KELLER SPRINGS LOFTS

LOFT APARTMENTS IN ADDISON, TEXAS

To: Jordan & Skala Engineers, Inc. RFI #: 16
14240 Midway Road, Suite 350 Date: 12/28/2011
Dallas, TX 75244 Job: EB-02 Keller Springs Lofts
Ph: 469/385-1616 Fax: 469/385-1615 Phone: 877-777-5115

DATE: 08-05-11
 PROJECT: 11129
 SHEET NUMBER: **E-1.3**
 RISERS

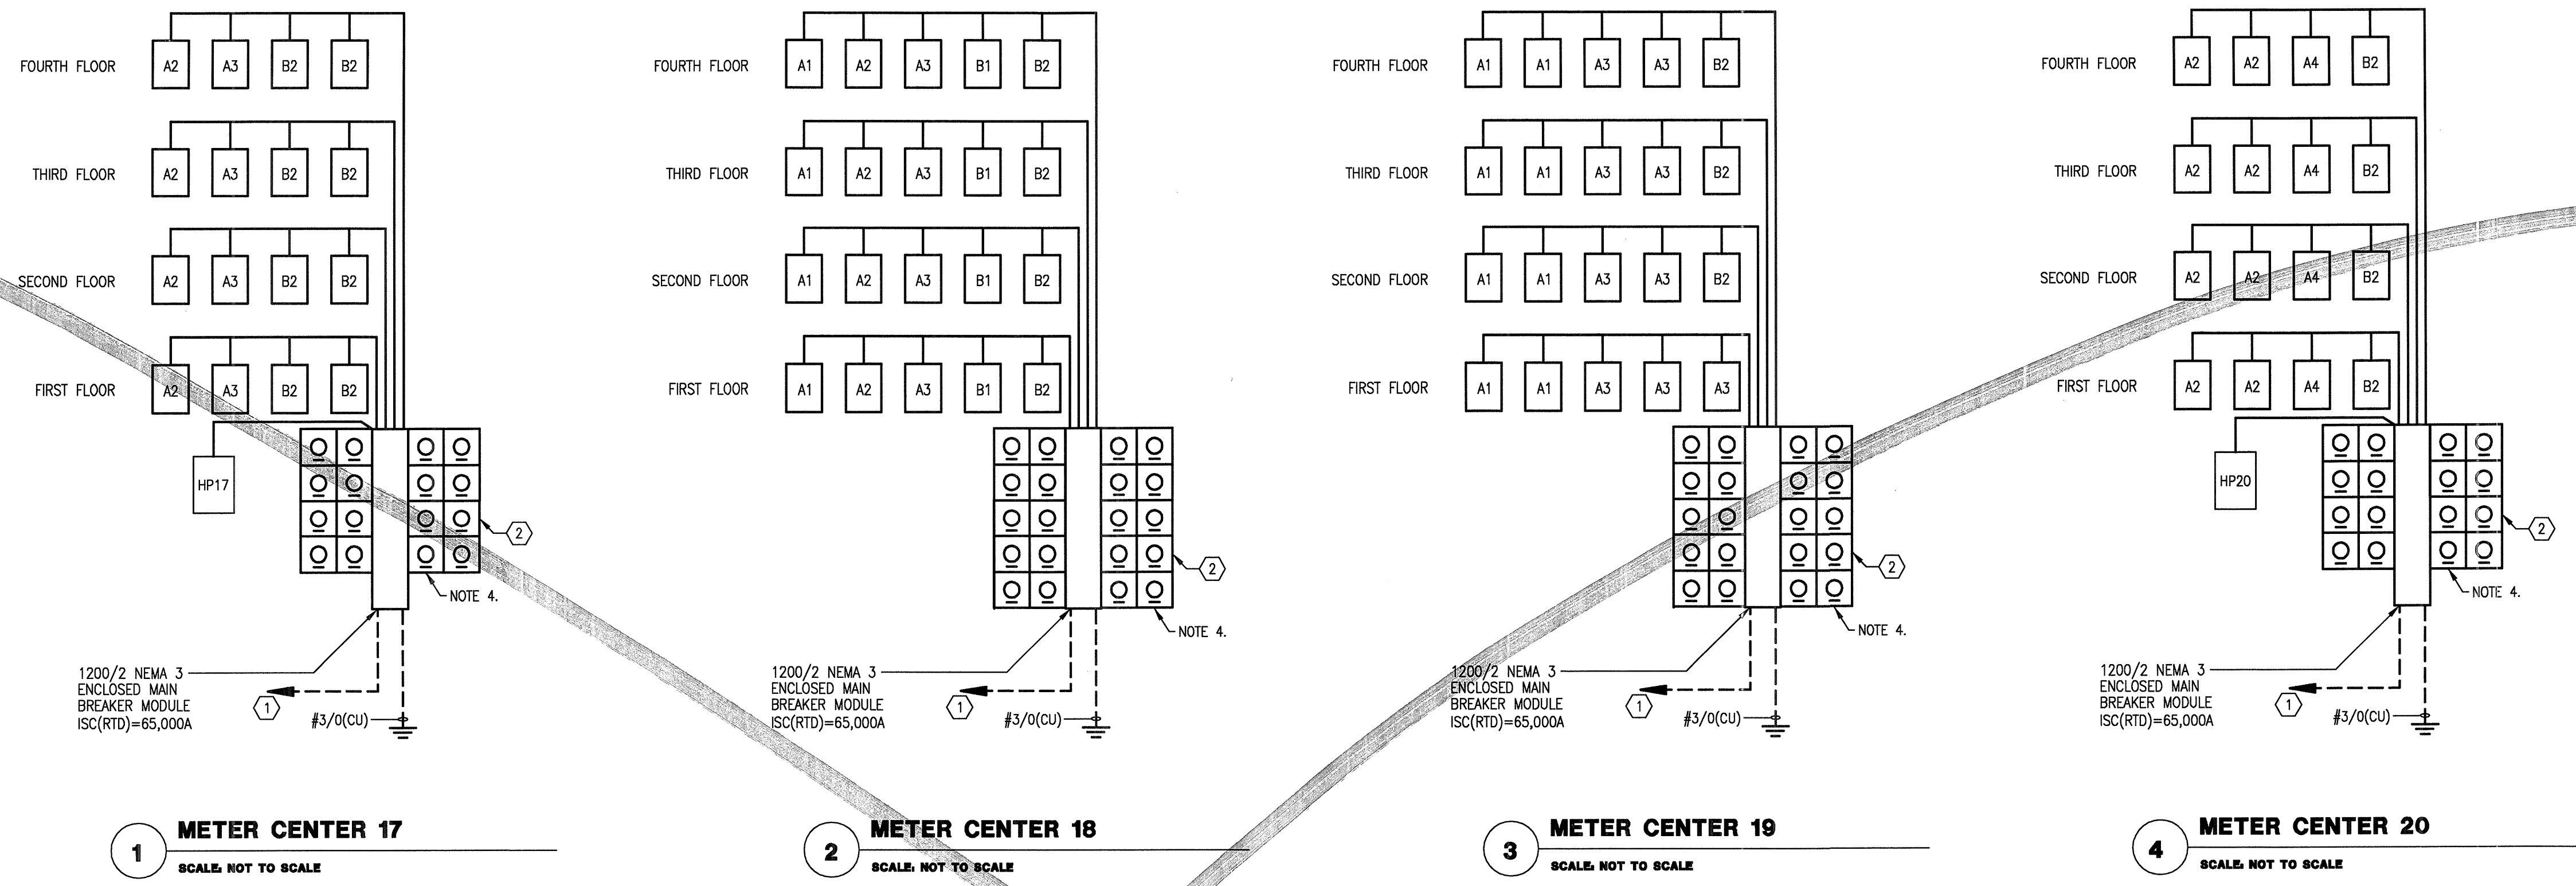
Request: Date Required: 1/24/2012
On sheet E-1.3 on 1/22/11 a Panel 'CP' was added to the panel as a design revision. Is this for the fountain courtyard including the fountain equipment?
Sheet E-1.7 Panelboard schedule 'CP' has a note for contractor to coordinate with landscape and architect on location of 'CP' Panel. In talking with my electrician and pool contractor, we all feel the location for the CP panel should be located at the pop-out area in building between the patio's located to the southeast of the fountain equipment vault, which would be about 14' away from the power. By locating this panel in the courtyard, it would make any future changes or additions for the power requirements to the courtyard readily available.
Requested by: Bryan Pichler
Embrey Partners, Ltd.

JSE Response: Panel 'CP' serves the fountain courtyard and the fountain equipment.

5 208/120V SINGLE LINE DIAGRAM
SCALE: NOT TO SCALE

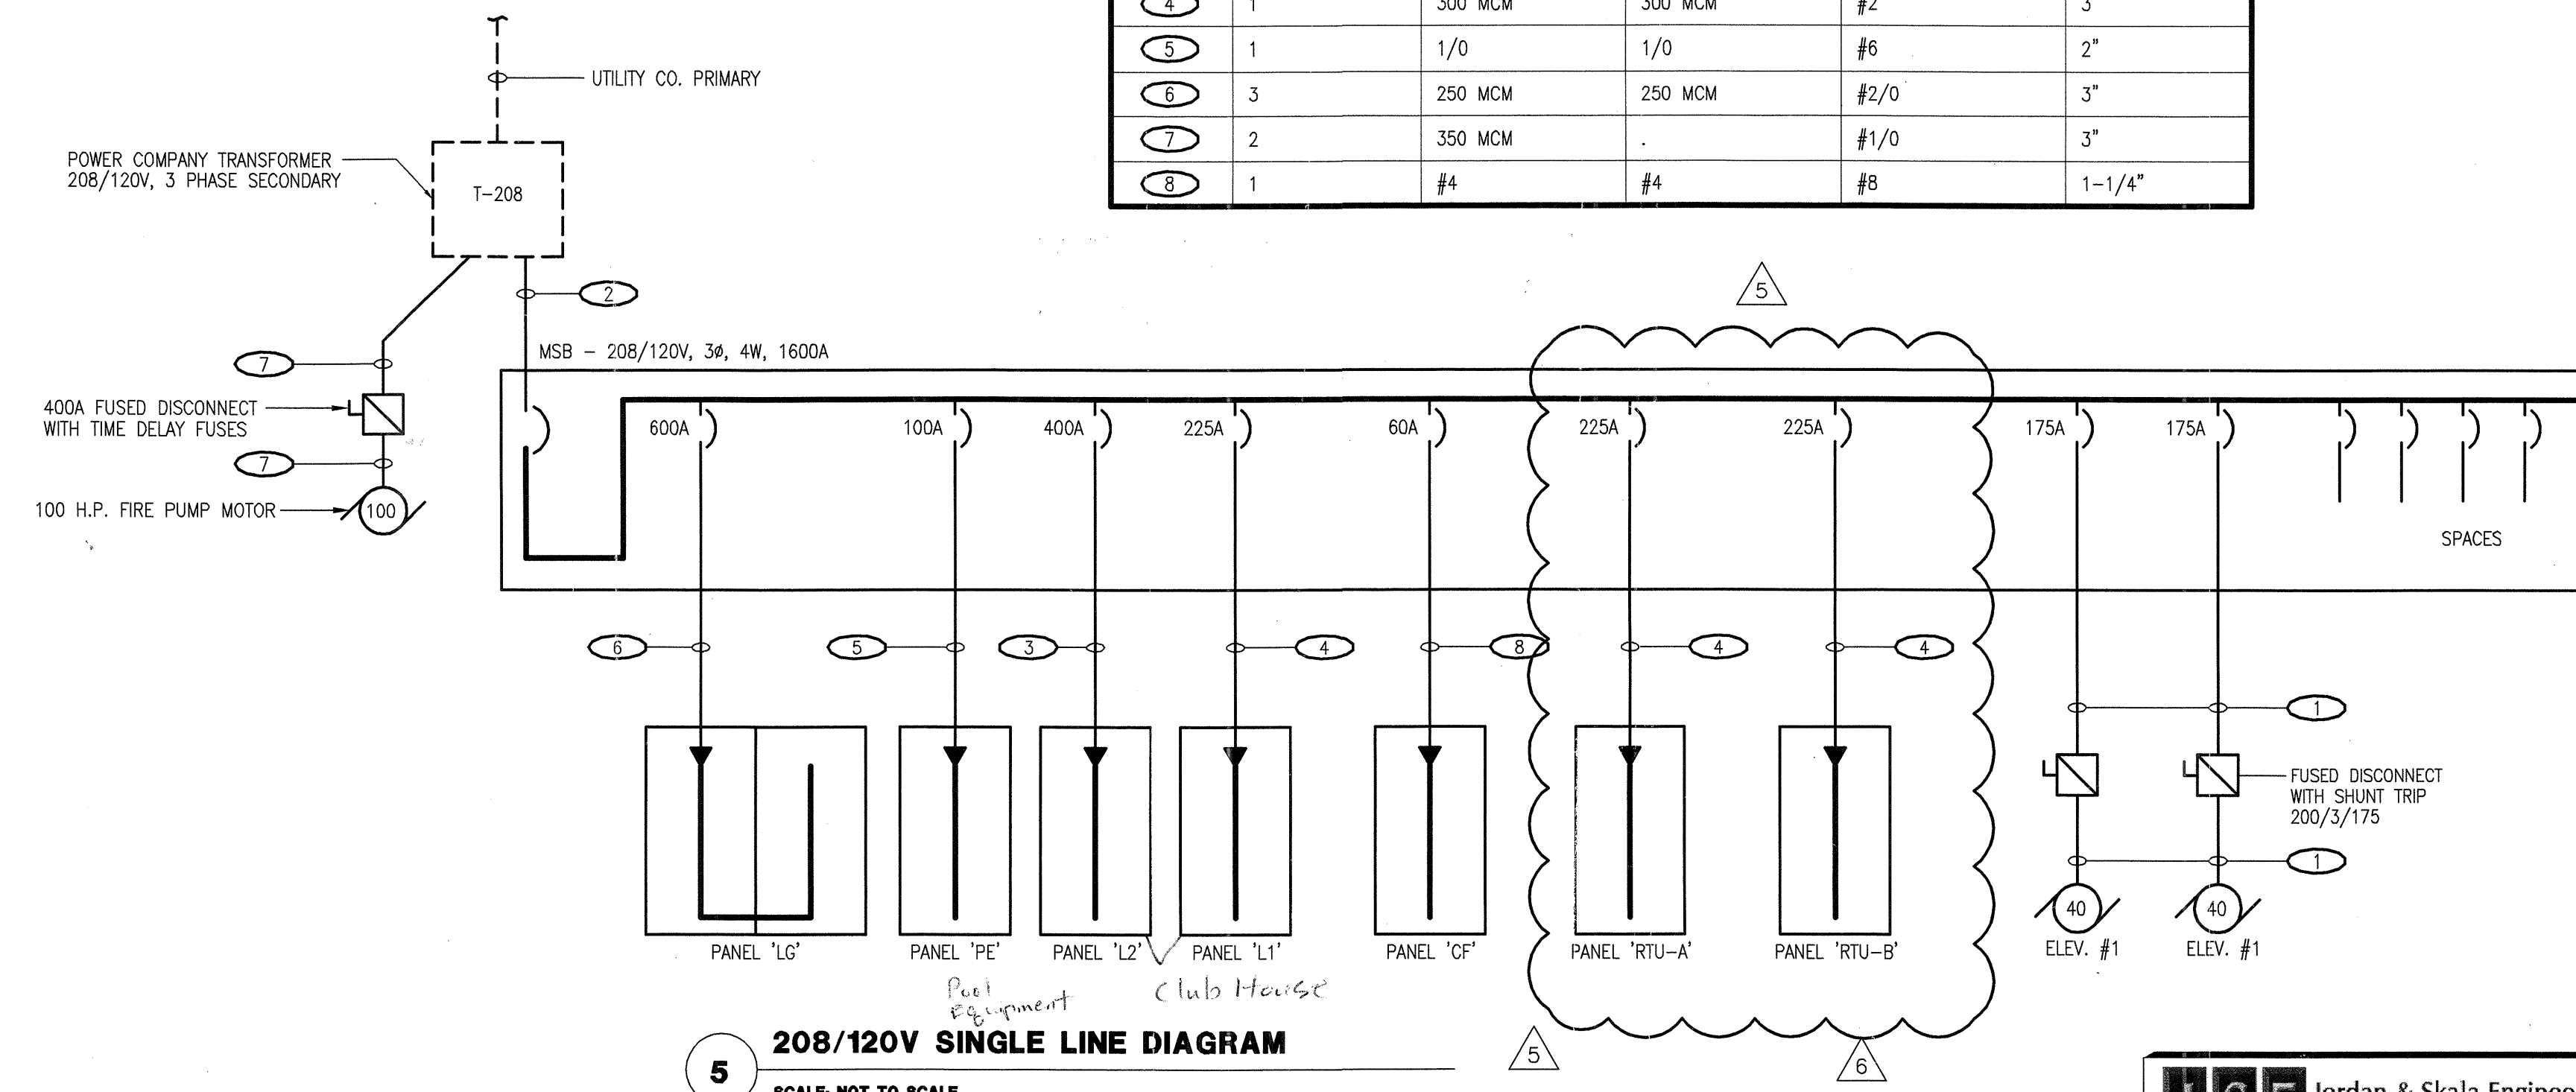
Request: Date Required: 12/2012
sheet E1.6 show RTU 1,3,4,5,6,7,8 being fed out of the house panel with 3 pole breakers house panels are 120/240V single phase according to TDI the HVAC subcontractor and attached cut sheets RTU must be 120/208V three phase we cannot feed 3-phase equipment from a single phase panel!

MSF proposes the following solution
1) the RTU be deleted from the house panels
2) RTU-2 be deleted from switchboard MSB
3) add (2) 3 pole breakers to switchboard MSB that will sub feed (1) 3-phase subpanel in each building (RTU-A & RTU-B) that will solely dedicated to services the (4) RTU units in each building
4) locate (1) of the sub panels (RTU-A) in the closet adjacent to HP-5 and the other (RTU-B) in the closet adjacent to HP-20
5) feed RTU from these locations with wire type and wire size as indicated on our sketch and per our voltage drop calculations for 5% voltage drop using the actual load of 38.1 amps at 208V 3 phase

The above listed proposes are acceptable and have been incorporated into the electrical plans. Reference the attached E1.3, E1.6, E1.7, E3.1B, and E3.1D. The revisions have been clouded with a delta 6 for reference.
